Pace Bus Depot Location Analysis

Additional notes from Working Group members:

Parkview Lot:

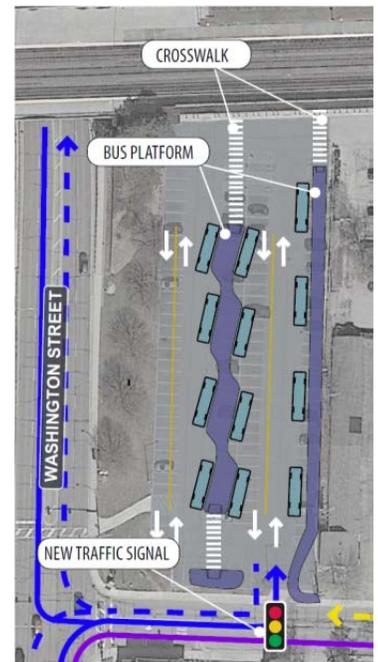
A bus depot should be open air and not understructure. Idling buses affect immediate air quality and the vision of a dark dingy low ceiling height terminal doesn't fit within the context of the surrounding neighborhood which may attract vagrants.

Capacity will be constrained by the size of the space, once adopted. Space will be hard to repurpose if needs change. Closed space may be less pleasant for commuters if it is dark and dirty. Idling buses will make air quality a problem, and may make it impossible to maintain a clean welcoming space. Closed, sheltered space will almost certainly attract loiterers and vagrants, which will detract from the commuter experience and be a safety risk for the neighborhood.

An at-grade bus depot with a building above would require ventilation designed accordingly, in consideration of air quality for bus passengers as well as users in the building above. Aesthetic concerns of a dark and low-ceiling height terminal can be addressed with lighting and increased ceiling heights, respectively.

An at-grade bus depot with a building above may be harder to repurpose. If implemented, the concept could take into consideration findings from the Parking Working Group regarding the repurposing of parking garages. If at-grade (with building above), the depot could be an open-air concept without walls, however, mechanical ventilation may still be required. Aesthetic concerns of a dark and low-ceiling height terminal can be addressed with lighting and increased ceiling heights, respectively.

DuPage Children's Museum

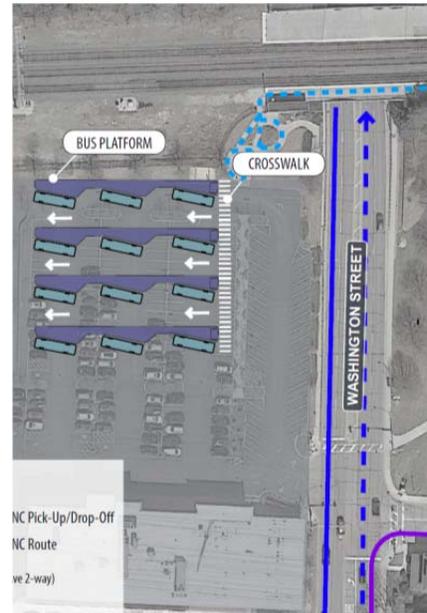
It doesn't necessarily separate buses from cars, if the museum lot is used either as a commuter or retail/office parking garage.

Arguably, kiss-n-ride should be on the museum parking lot, with bus depot at the station. This would get the greater majority of people (bus riders) dropped as close as possible to the station, and reduce the vertical integration problems. Meanwhile, a little extra car traffic on the museum lot would not be the same type of traffic problem as would be for buses mixed with parking traffic.

Note that this [a bus depot on the museum lot] would not be as great a concern if kiss-n-ride was placed on the museum lot, because the north side drop off is likely to be close to the tracks and more accessible to ADA compliant ramps under the tracks. Kiss-n-riders can choose where to make the drop. Bus riders are stuck with wherever the bus drops them.

Correct; the lot could have other commuter or private land uses. This could result in buses and cars sharing internal circulation routes.

Kiss-n-ride could be implemented on the museum lot with development above. Traffic should be considered given the higher volume of kiss-n-ride vehicles compared to Pace buses. Intersection function of North/Spring/Washington will be important. It is reasonable to assume that some commuters may use the museum lot today for pick up and drop off, particularly if coming from west of Washington St.

Placing a bus depot on the museum lot does result in a longer ADA route than current conditions, particularly when the Ellsworth tunnel must be used. A proposed Core Functional Component is to maintain kiss-n-ride facilities on both sides of the tracks. Doing so would allow kiss-n-ride users to avoid the Ellsworth tunnel or other pedestrian rail crossings.

4th Avenue

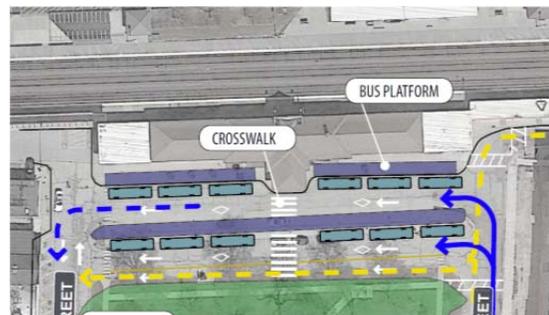
Northbound traffic will not be able to access 4th Ave when the gates are down, so drivers may chose to instead not use a formal kiss and ride designated drop off area.

Dumping 4th Ave traffic into the Burlington Square area does not truly separate kiss-n-ride traffic from bus traffic. It also leaves room for kiss-n-ride people to drop off in front of the station, which they will do if they see open space.

This is a serious detriment to the neighbors, regardless whether they are owner-occupied or rentals. 4th Ave is narrow even for a one-way street. Cars pulling in and out of drop-off stalls parallel to the flow of traffic would be a significant problem. Back-ups at the airports are severe, even with more space and extra lanes to work with.

4th Ave will be inaccessible if traffic backs up on Loomis while the RR crossing gates are down.

If 4th Avenue is converted to a westbound one-way street, kiss-n-ride users driving north would turn left onto 4th Avenue from Loomis. If traffic on Loomis was blocked by a train with gates down, users may not be able to make the turn onto 4th Avenue. As one potential solution, the City could consider adding a northbound left turn lane at this location.

Westbound 4th Avenue traffic would exit south on Ellsworth, while Pace buses would travel north on Ellsworth. This would create a condition where Pace buses must turn left into the loading berths across kiss-n-ride departing traffic. Regardless of bus depot location, enforcement may be needed to prevent kiss-n-ride users from stopping in designated bus lanes.

This improvement was suggested in the 2012 bus depot study, which noted “While buses would not queue on neighborhood streets, kiss-and-ride activity would be relocated to 4th Avenue between Ellsworth Street and Loomis Street. Feedback with neighbors along 4th Avenue indicated opposition to this kiss-and-ride staging concept.” 4th Avenue is approximately 20’ wide; should a vehicle stop to parallel park, it would block traffic until fully parked.

If 4th Avenue is converted to a westbound one-way street, kiss-n-ride users driving north would turn left onto 4th Avenue from Loomis. If traffic on Loomis was blocked by a train with gates down, users may not be able to make the turn onto 4th Avenue. As one potential solution, the City could consider adding a northbound left turn lane at this location.

Burlington Square

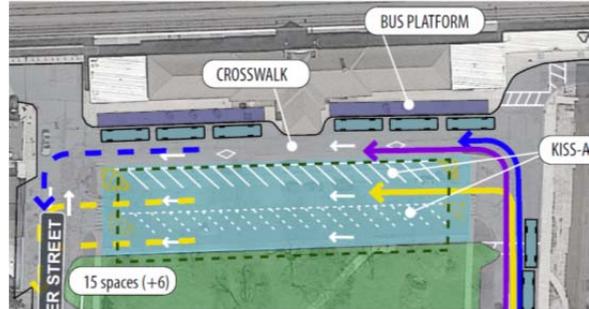
The differences between the 4th Ave and the two Burlington Square concepts is only in the location of the kiss-n-ride. We should consider all options for kiss-n-ride, independent of the location of the bus depot. The parkview lot and the museum lot both could serve as spots for kiss-n-ride. Either would more effectively segregate cars from buses, and would leave the space in front of the station dedicated for bus traffic.

Diagonal stalls would greatly improve capacity and experience for drop-offs and pick-ups. This would also encourage kiss-n-ride drivers to be in the right place and leave the bus platform for the buses.

They [Pace & kiss-n-ride vehicles] would be separated where they park, which currently seems to be the place of greatest contention.

This is a very attractive idea, and one that would substantially improve the neighborhood experience at minimal relative cost.

The kiss-n-ride could be located independently of the bus depot on the Parkview or Museum lots with development above. Similar to the Pace bus depot, final traffic patterns and geometries should be considered when reviewing these options.

Diagonal stalls could help prevent loading/unloading vehicles from blocking lanes of traffic, when compared to parallel stalls. Additionally, Uber and Lyft vehicles are identified by their license plates. Facing vehicles towards the station may help riders locate their designated vehicle.

This concept intends to limit the use of bus lanes by kiss-n-ride vehicles. However, enforcement may be needed to prevent kiss-n-ride users from stopping in designated bus lanes.

Given the limited off-peak hour uses of the bus depot and kiss-n-ride facilities, it is important to investigate multi-purpose uses of these neighborhood areas.

Burlington Square Alternate

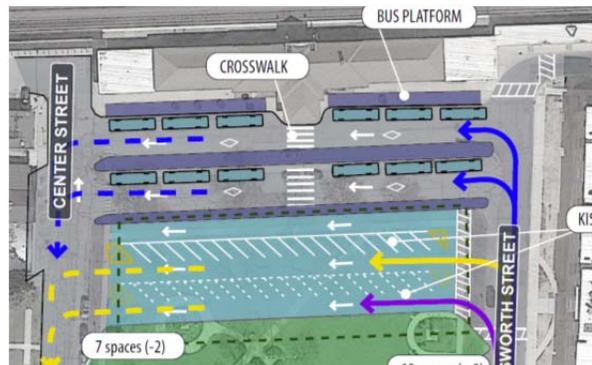
They [Pace & kiss-n-ride vehicles] would be separated where they park, which currently seems to be the place of greatest contention.

Could encroachment be limited by using only a single row of diagonal stalls? In terms of capacity, would that improve on today's configuration? Instead of pull-through stalls, could pull-in, back-out configuration be used?

Input or study on the use of Burlington Square Park might be helpful. This is one of very few green spaces within the neighborhood south of the tracks and east of Washington. But, knowing how the space is used might make it easier to assess whether taking some space from the park would be a detriment to the neighborhood.

This is a very attractive idea, and one that would substantially improve the neighborhood experience at minimal relative cost.

This concept intends to limit the use of bus lanes by kiss-n-ride vehicles. However, enforcement may be needed to prevent kiss-n-ride users from stopping in designated bus lanes.

This concept provides approximately 19 diagonal stalls with a single row, and 38 with two rows of diagonal stalls. Currently there are 11 designated parallel parking stalls for kiss-n-ride functions.

Any impacts to Burlington Square Park for transportation improvements would need to be reviewed and approved by the City and Park District.

Given the limited off-peak hour uses of the bus depot and kiss-n-ride facilities, it is important to investigate multi-purpose uses of these neighborhood areas.
